## REVISED RESPONSE TO REQUEST FOR ADDITIONAL INFORMATION

### APR1400 Design Certification

Docket No. 52-046

**RAI No.:** 557-9199  
**SRP Section:** 03.08.05- Foundations  
**Application Section:** Tier 2, Section 3.8.5 and Tier 1  
**Date of RAI Issue:** 12/01/2017

Figure 2.2.2-2 Emergency Diesel Generator Building Block Plan

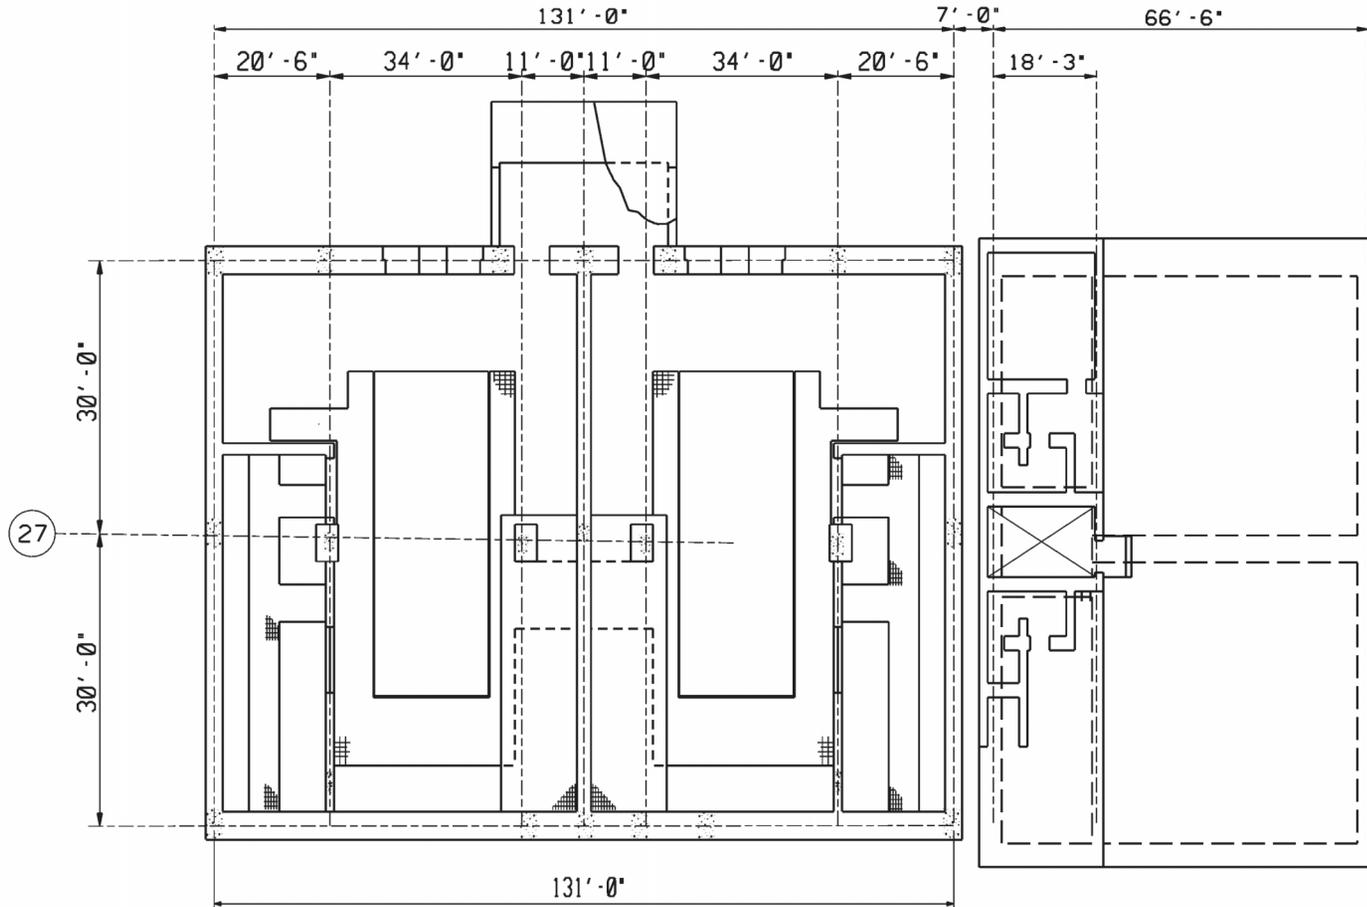
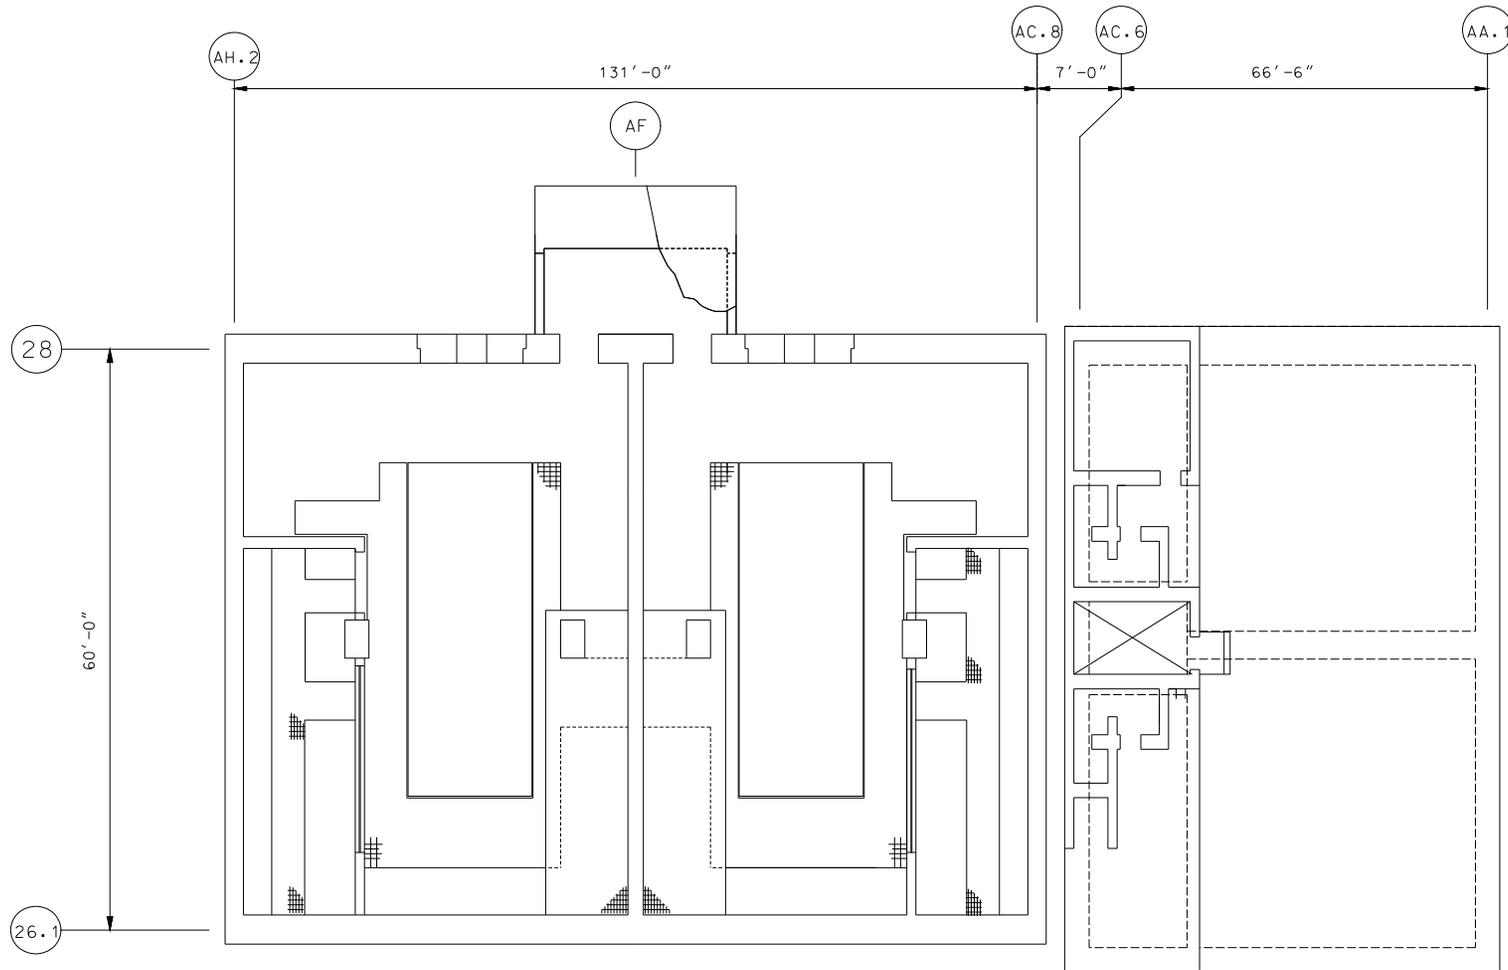
The dimensions and elevations of the EDG building block are as described in Table 2.2.2-1, Figure 2.2.2-1 and Figure 2.2.2-2.

3. <del>The key dimensions of the EDG building block are as described in Table 2.2.2-1, Figure 2.2.2-1, and Figure 2.2.2-2.</del>	3. <del>Inspection will be performed to verify that the as-built wall and slab thickness conform to the structural configuration.</del>	3. <del>A report exists and concludes that the EDG building block as-built wall and slab thickness conform with the structural configuration as described in Table 2.2.2-1, Figure 2.2.2-1, and Figure 2.2.2-2.</del>

The tolerances for the dimensions in Table 2.2.2-1 and Figures 2.2.2-1 through 2.2.2-2 shall be in accordance with ACI 117(2010 edition) for concrete structures and ANSI/AISC 303(2010 edition) for structural steel members /structures. Any provisions in these codes which provide acceptance criteria for conditions when tolerances are exceeded shall not apply, but a licensee referencing the APR1400 DCD may deviate from the tolerances in these codes using alternative acceptance criteria, if these acceptance criteria are approved by the NRC. As-built dimensions will also be evaluated to verify compliance with the design bases and applicable codes and standards identified in Table 2.2.1-5.

Figure 3.8A-67 Emergency Diesel Generator Building Block Section

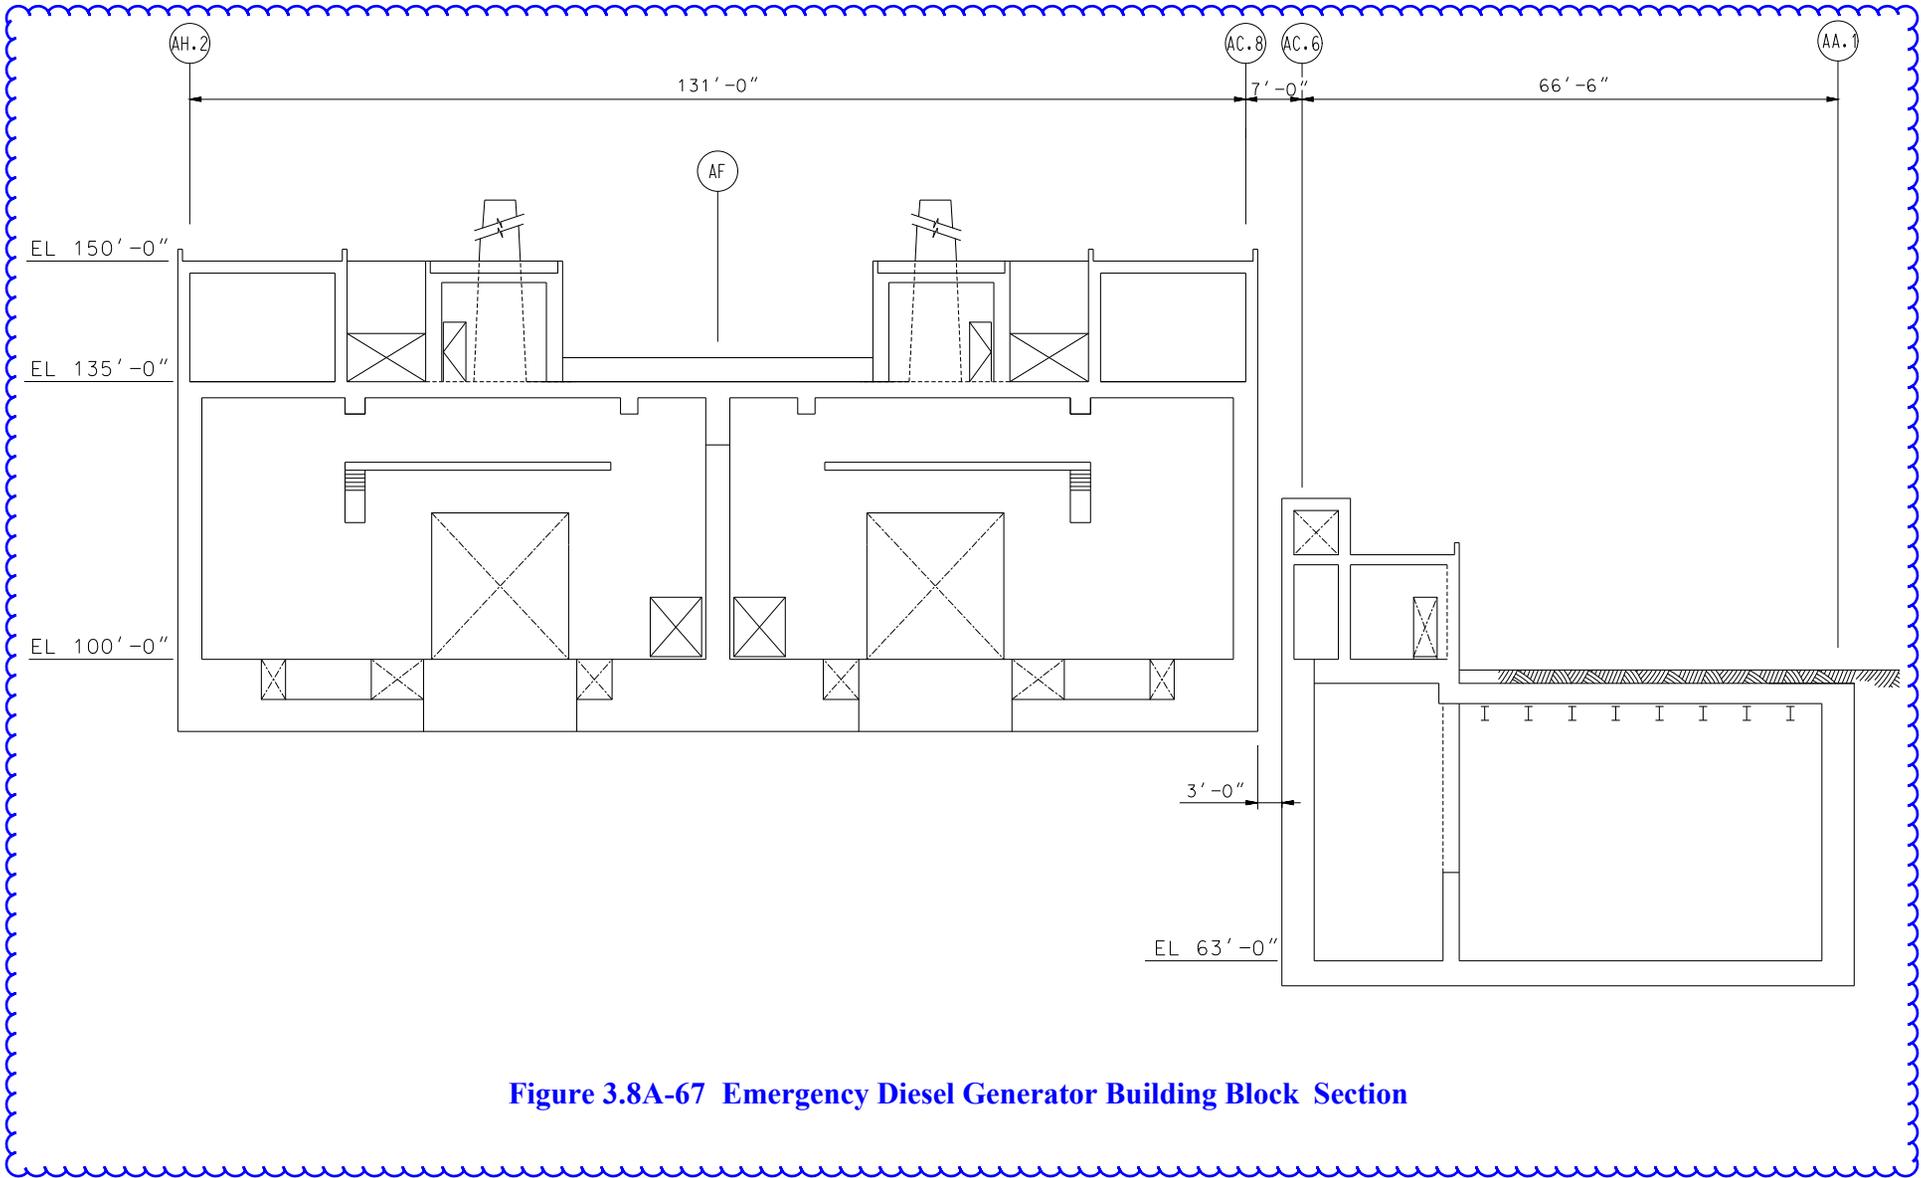
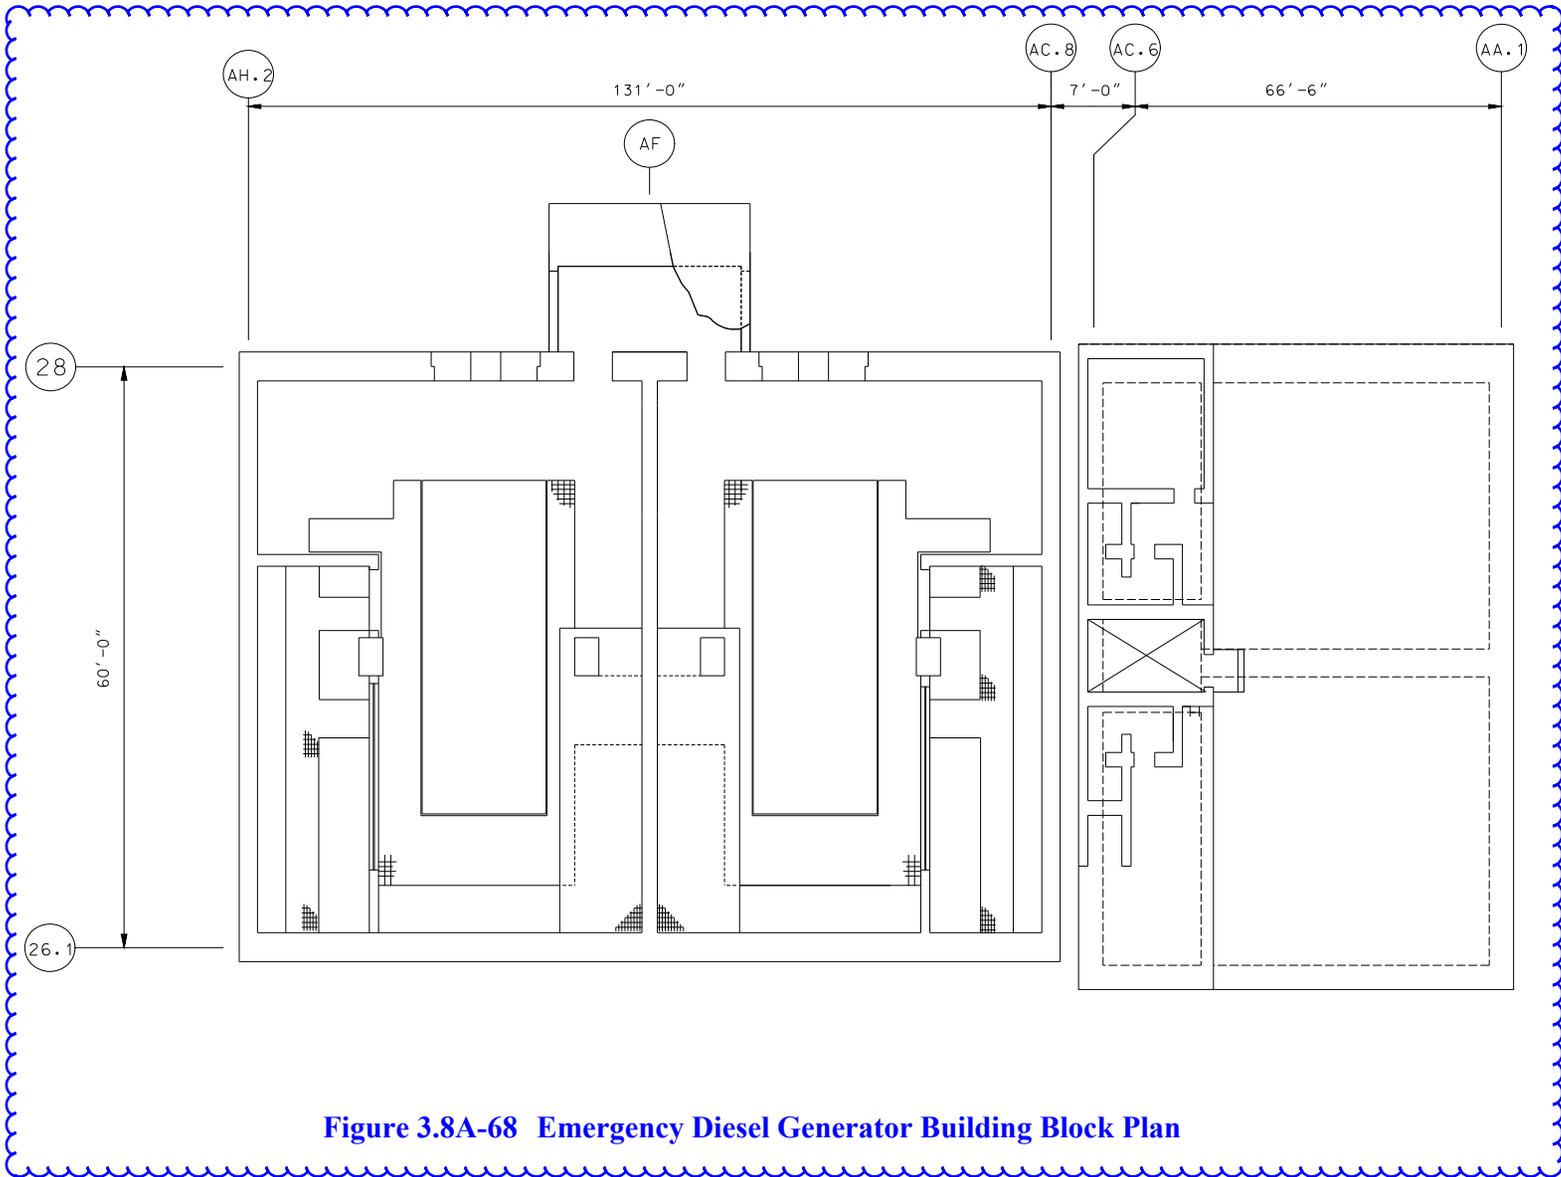
Finally, additional figures were added to Tier 2 to depict the arrangement of the EDGB Building and structures (Subsection 3.8A.3.1, Figures 3.8A-67 and 3.8A-68). These are shown in Attachment 2.
